PLAN COMMISSION

February 19, 2015

Approval Sought

EDENBRIDGE PARKING LOT
18134 S. 66th Court

PHASING DIAGRAM

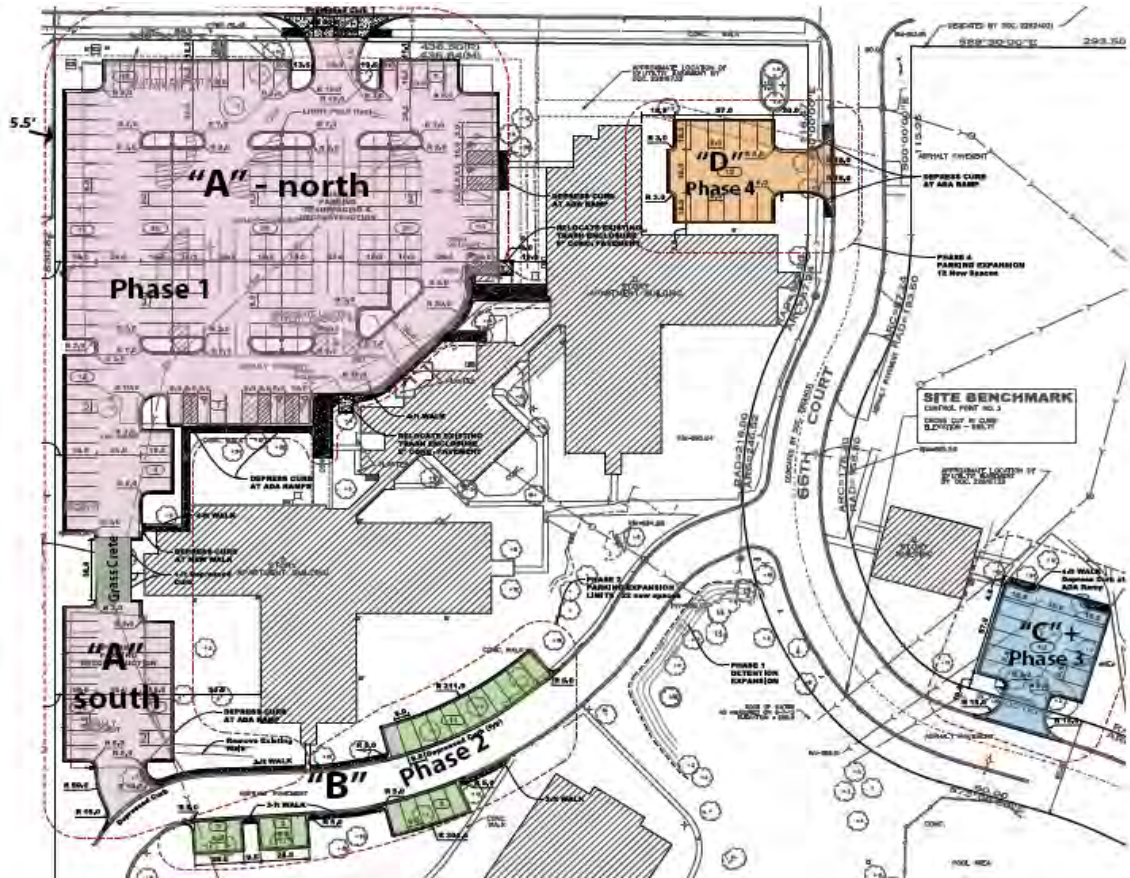
The Applicant proposes to increase the number of parking spaces throughout the development in four phases (see Phasing Diagram on the next page) as outlined in the table on the next page. No time frame has been submitted for the various phases. Improvements will be made to the storm detention pond and additional landscaping will be provided to screen the new parking areas. New lighting has been proposed in the Fulton Commons parking lot and in the new parking areas (“B”, “C”, and “D”).

Open Item #1: *The Applicant must identify a timeline for phasing the parking lot improvements.*

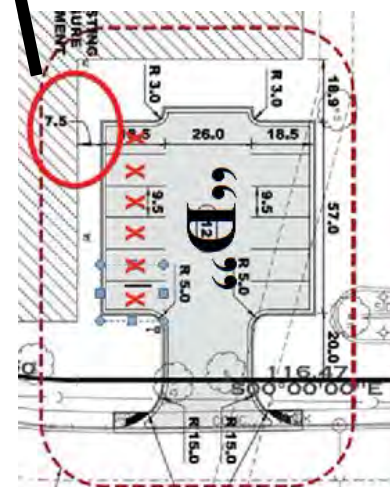
The Applicant has also proposed additional parking at the northeast corner of the north Fulton Common building (Area “D”). This parking lot provides an additional twelve (12) parking spaces. Staff has expressed concern regarding the proximity of this parking lot to the north and east facades of the building (see photo and red circle within the diagram to the right). The parking lot is located only 7.5’ from the outdoor living areas of the first floor residents.

The Applicant has stated that residents have expressed a strong desire for parking in close proximity to their dwelling units; however, Staff is concerned about headlight glare, quality of life, and use of the outdoor living space. With the curb located 7.5’ from the building façade, the bumper overhang can encroach an additional 2-2.5’, which could result in a small 5-5.5’ separation between a car bumper and outdoor patios. Staff has recommended that the Applicant remove the south six (6) parking spaces in this area or relocate the lot further away from the building and seeks the Plan Commission’s concurrence on this item.

Open Item #2: Proximity of parking area “D” to outdoor living areas in the north Fulton Commons building.

ACCESSIBLE PARKING

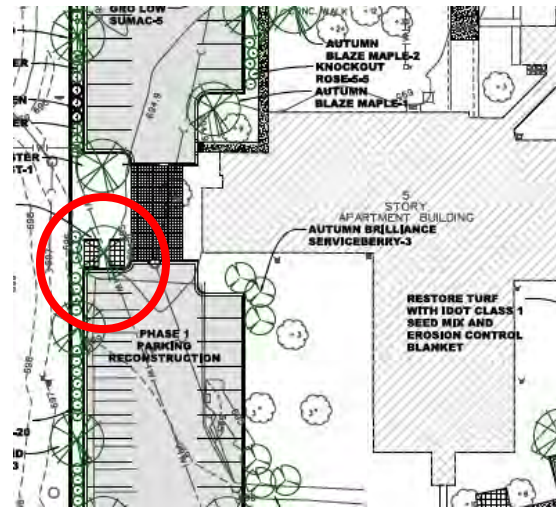
With the proposed parking reconfigurations there will be a total of 204 new parking spaces. Per the Illinois Accessibility Code there must be seven (7) accessible parking spaces provided in close proximity to accessible entrances. The proposed plan identifies six (6) spaces, therefore one (1) additional accessible parking space must be provided.

Open Item #3: Insufficient accessible parking spaces.

Plan View

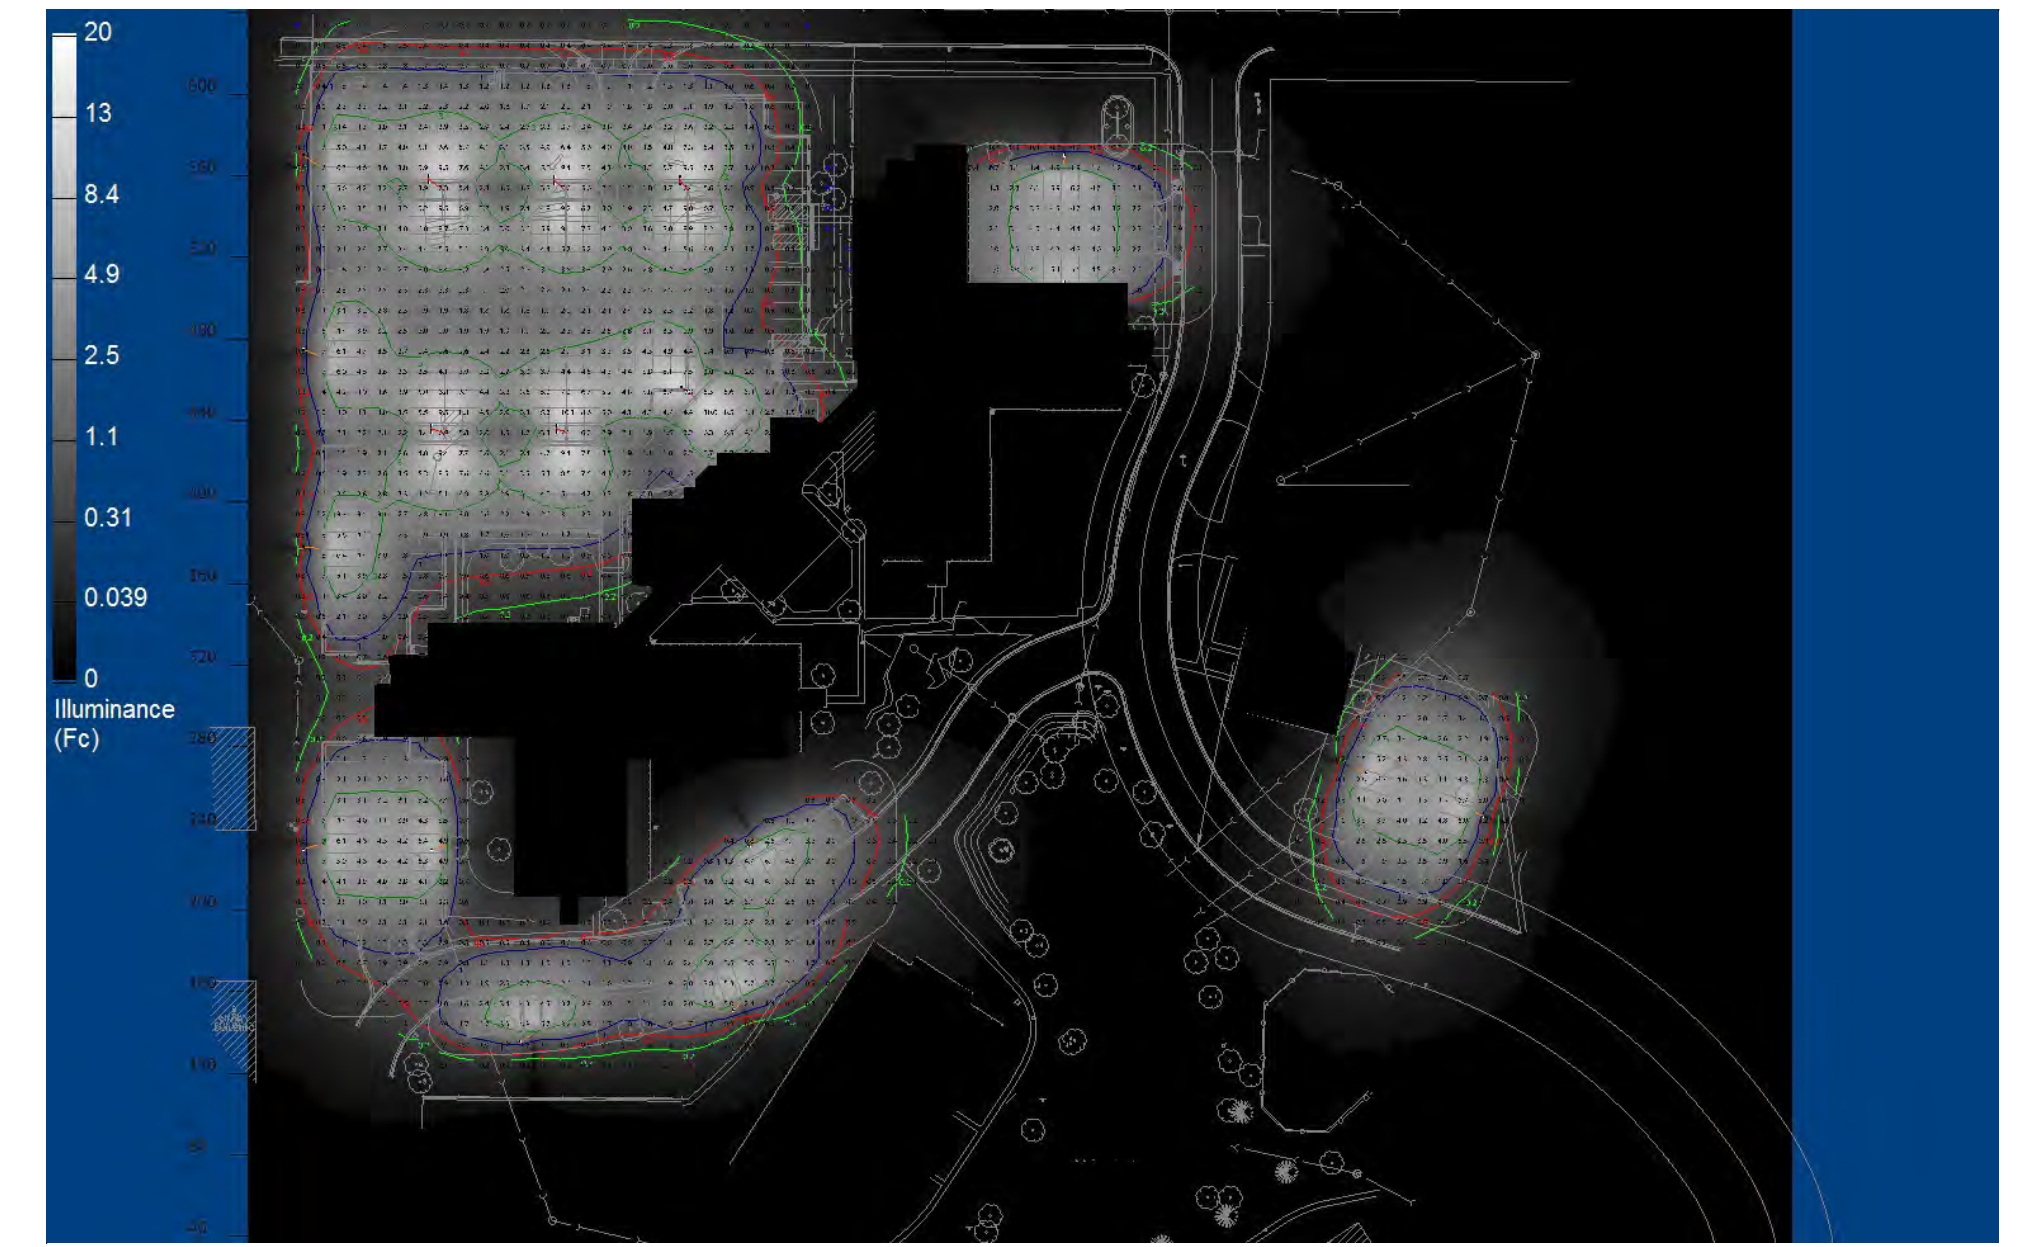
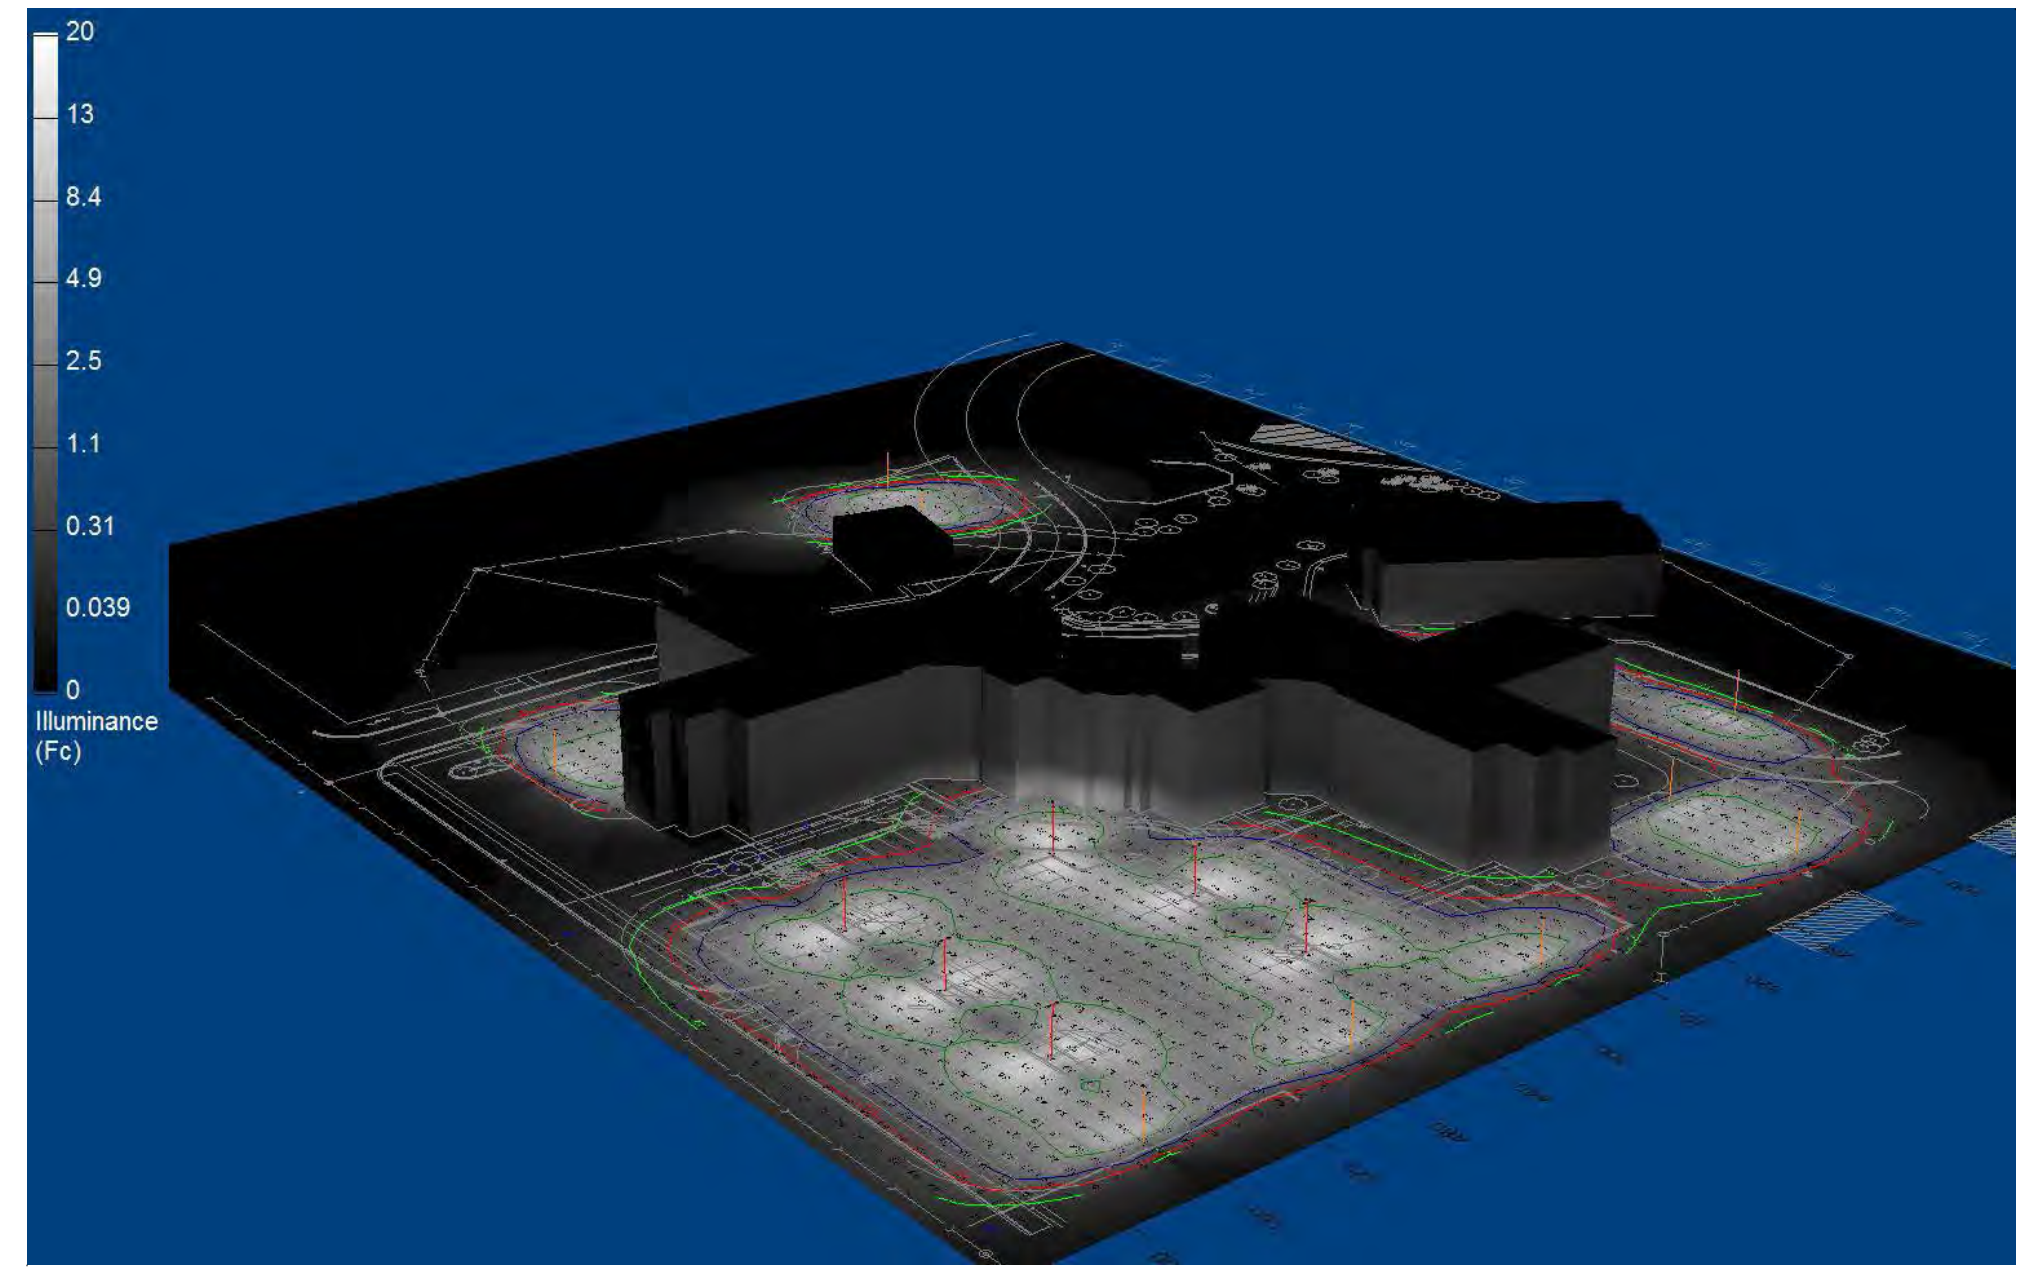
The Village Zoning Ordinance requires a photometric reading of 0.5 foot candles or less at the property lines. The property is in conformance with this requirement with the exception of the west property line where the 0.5 foot candle contour varies a distance of 3-5’ west of the property line. This will have a minimal impact along the adjacent detention pond; however, at the northwest corner of the parking lot (“A”), the 0.5 contour crosses the asphalt driveway of the adjacent property owner in a small area. With the addition of evergreen plantings in this area the light shed may be mitigated. Staff has consulted with the Lighting Consultant regarding this issue and they are investigating opportunities to remedy.

Open Item #6: Photometrics are exceeding ordinance limits at west property line.
